ARCHITECT'S SUPPLEMENTAL INSTRUCTIONS

PROJECT:	The Residence at Green Meadow New Senior Development San Angelo, TX	Report No.	One (1)
OWNER:	Overland Property Group Dan Maximuk 234 N. Santa Fe Ave, Suite A Salina, KS 67401	Date	Dec. 18, 2024
CONTRACTOR:	MCP Group 3501 SW Fairlawn Rd. Topeka, KS 66614	Architect's Proj No.	24-3395
		Contract For:	General Construction Mechanical, Electrical

Civil
SITE PLAN

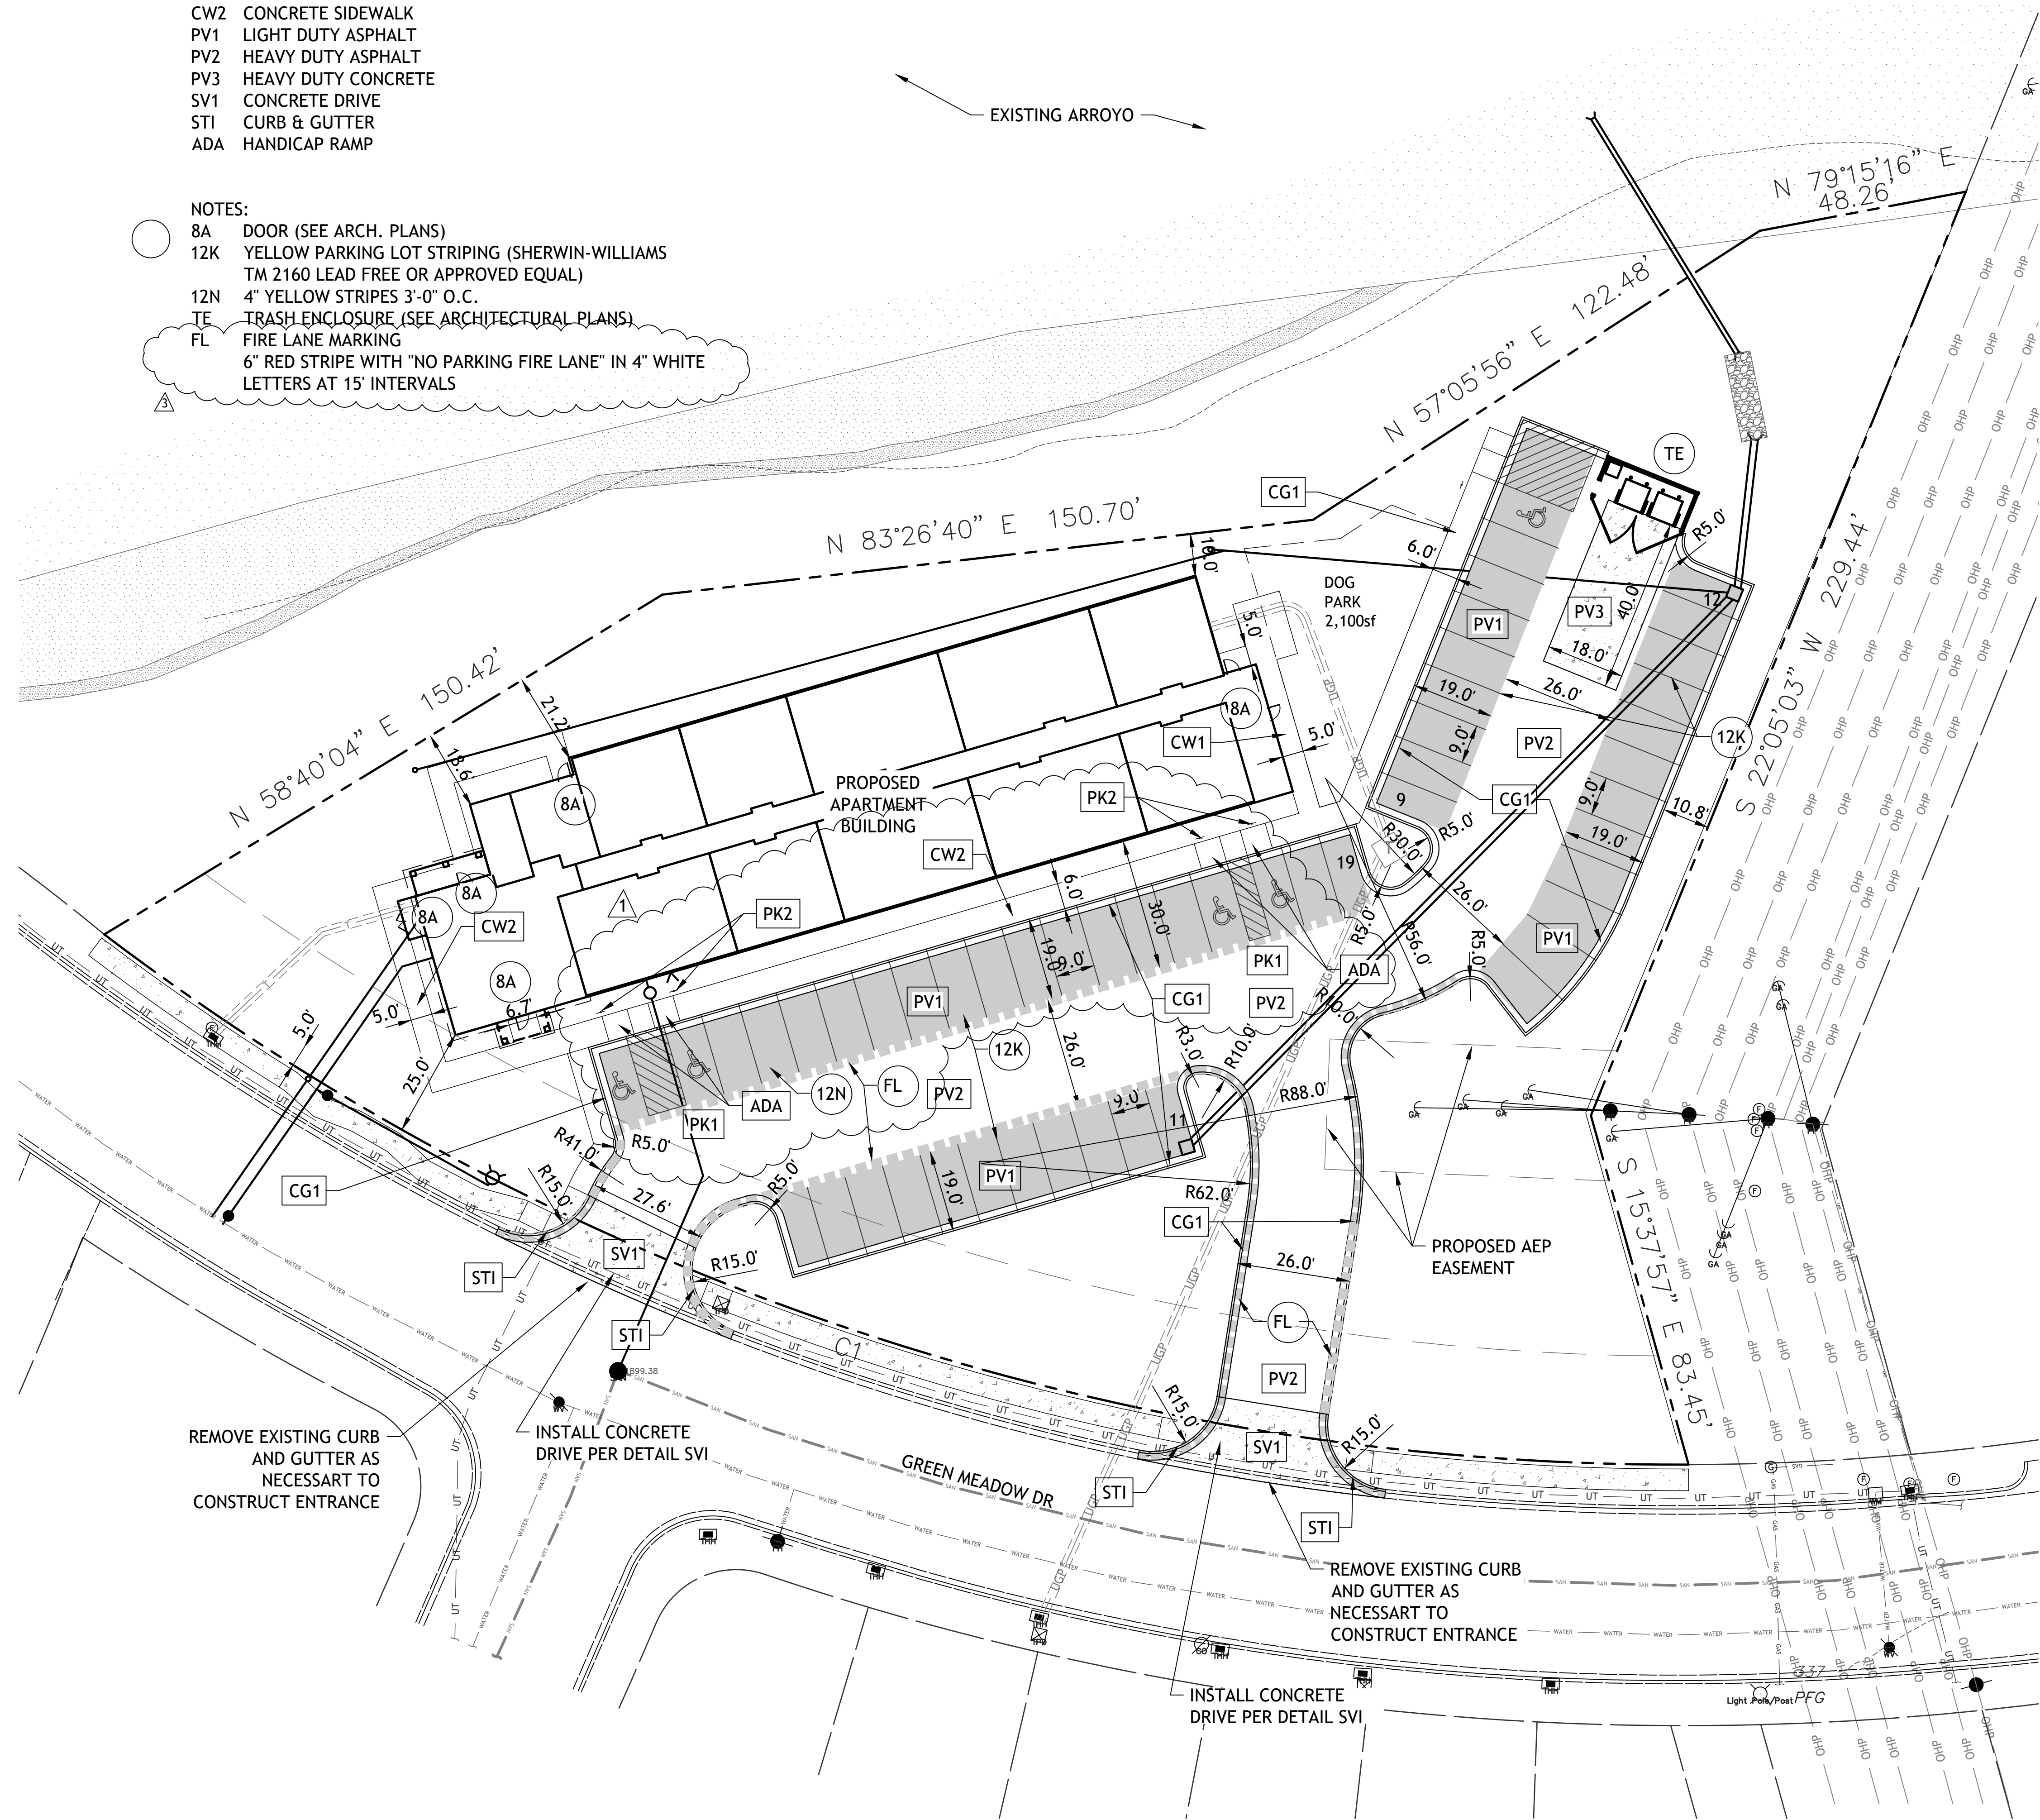
- 1) Sheet C-3 Site Plan:
 - a. Fire hose lay with distance has been added.
 - b. Fire lane markings/stripping has been added.
- 2) Sheet C-4 Utility Plan:

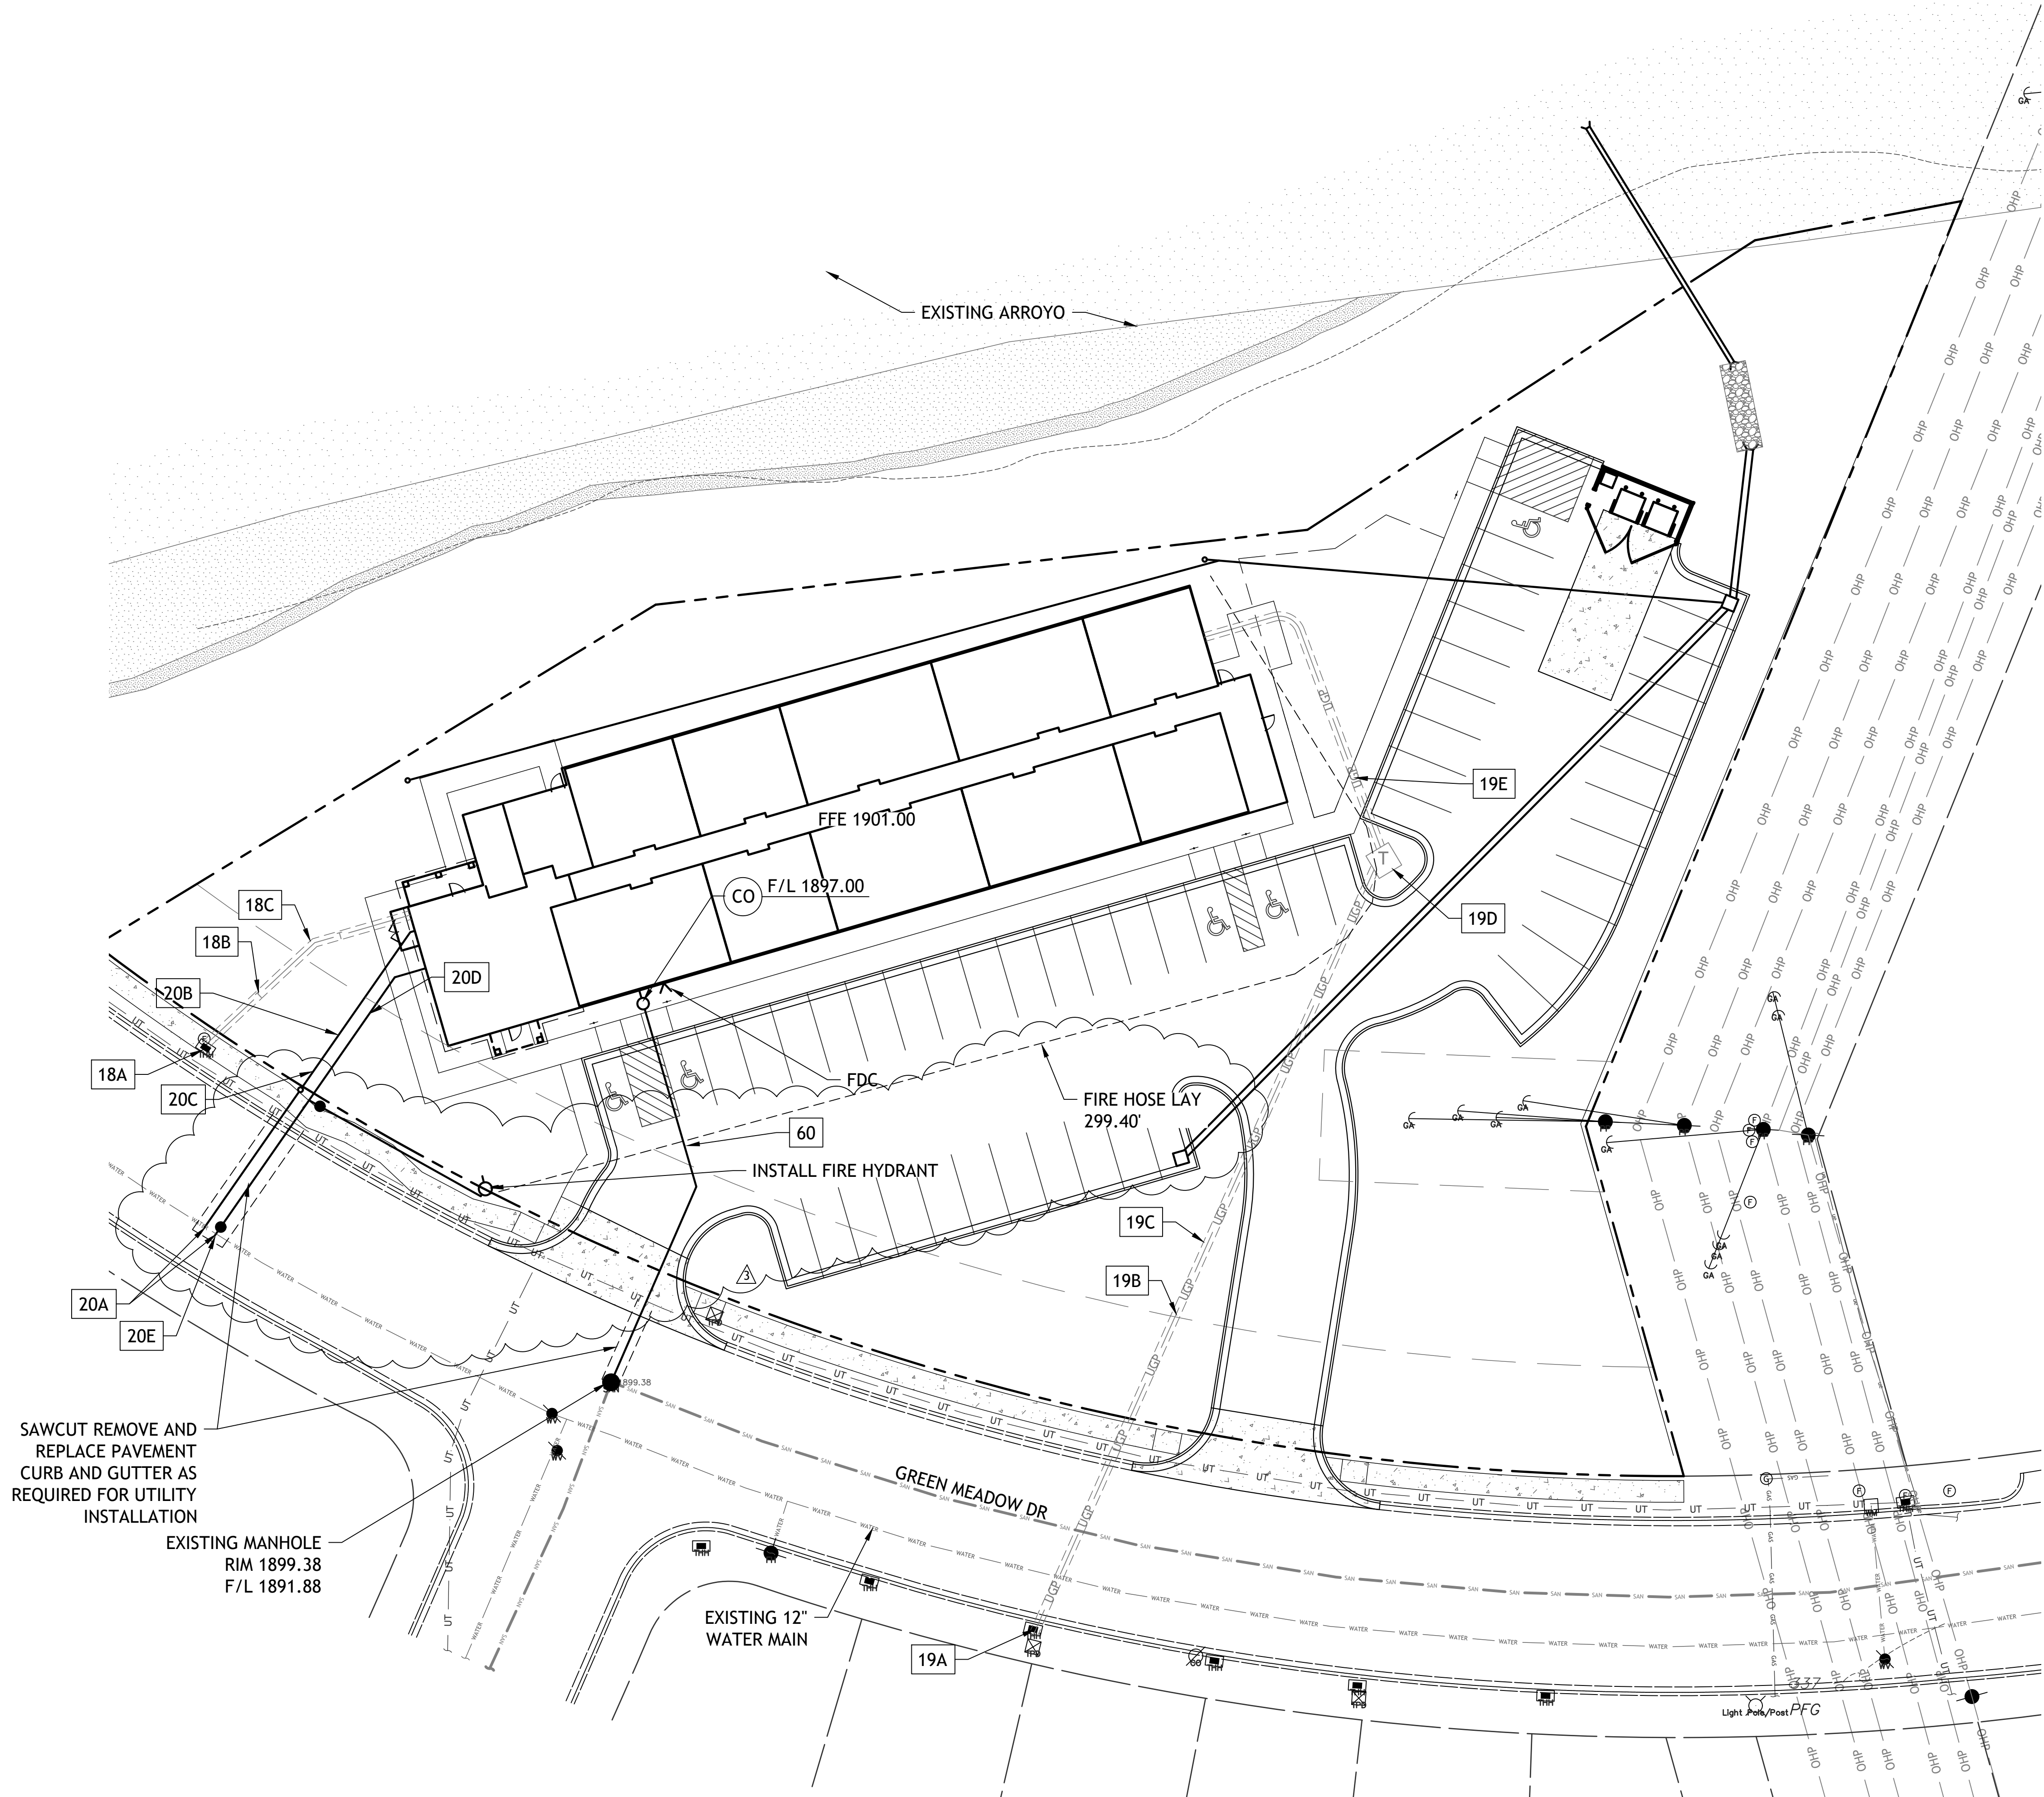
- a. Clarification: The FDC is shown. The FDC is located on the front of the building approximately 50' east of the southwest corner of the building.
 - b. Clarification: The line for the fire service is shown as 6". The fire hydrant is shown coming off this 6" line. The plan shows a separate tap for the 2" domestic service.

- c. Clarification: The valve has been shown on the 6" fire service line. The 6" connection is shown as a tapping sleeve and valve.
 - d. A valve has been shown on the fire hydrant lead. The valve is also indicated on the detail for the fire hydrant installation

- e. Water meter has been moved to inside the right of way.
- 3) Sheet C-9 Details - Pavement detail has been revised to reference the Texas Department of Transportation (in lieu of Missouri).

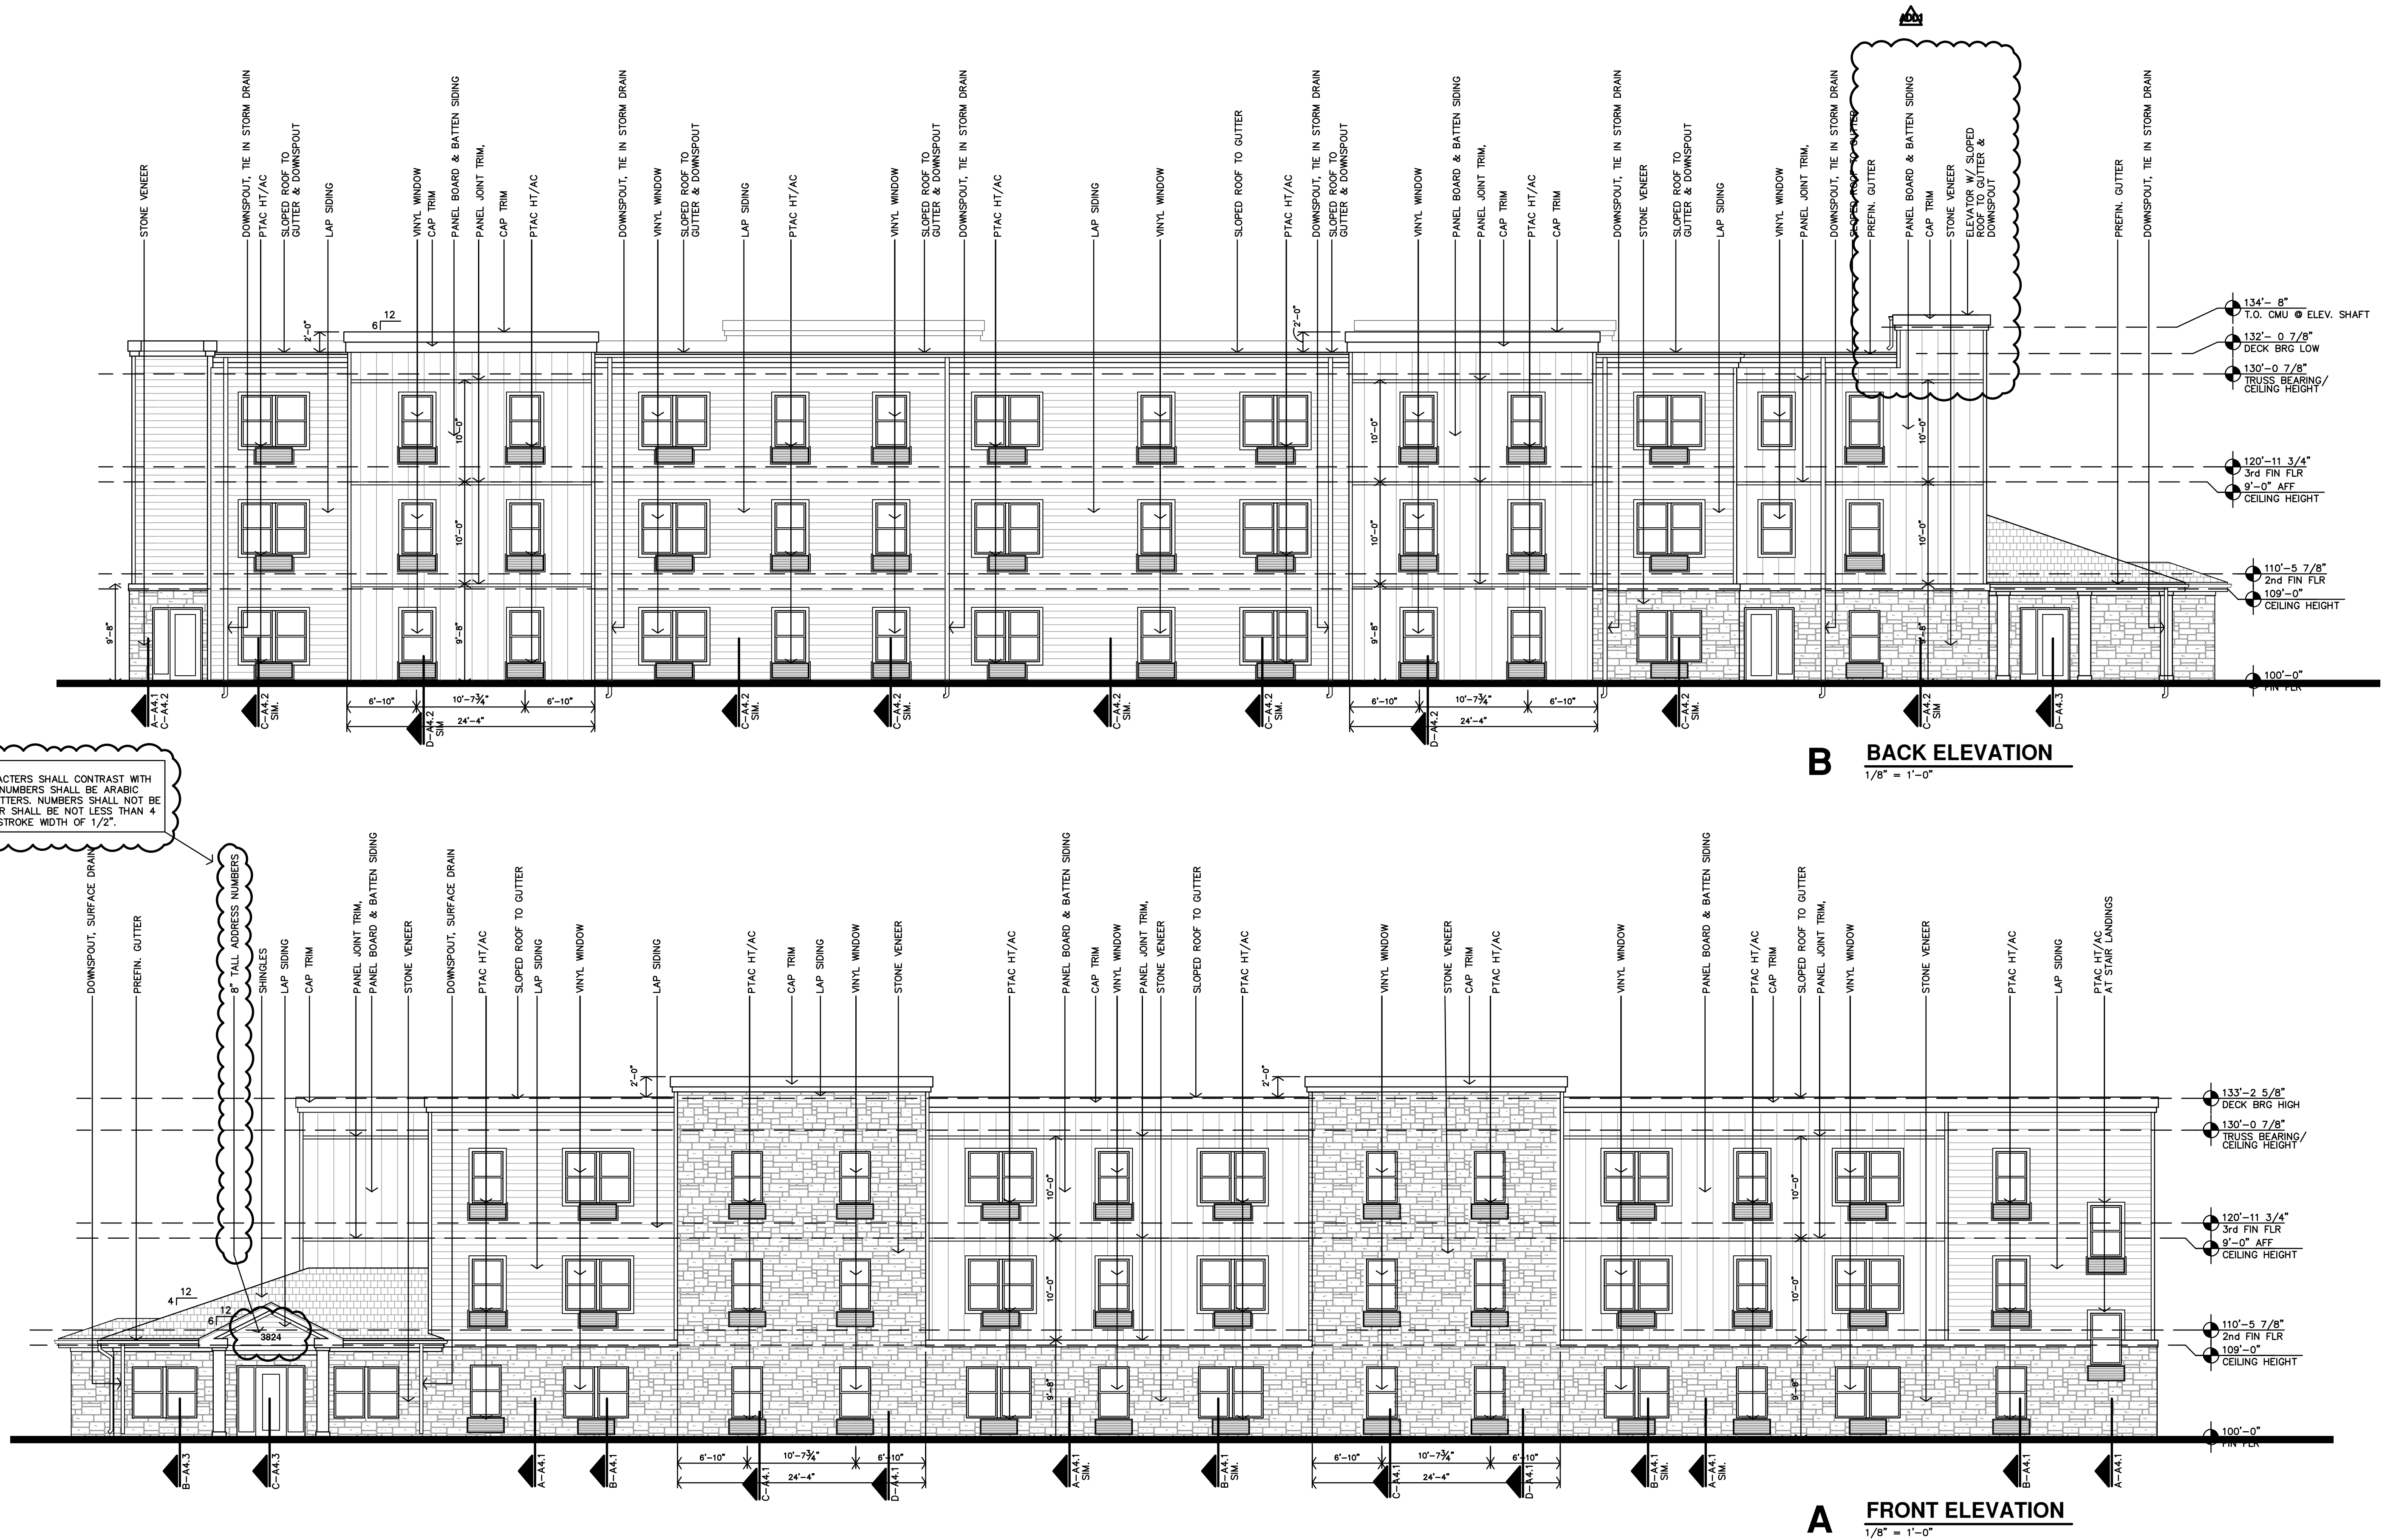
- 6) Sheet A2.7 - Assemblies: Code references have been revised to reflect the 2021 IBC designations & section call-outs.
- 7) Sheet A3.1 – Address numbers and notes have been added to the front elevation.
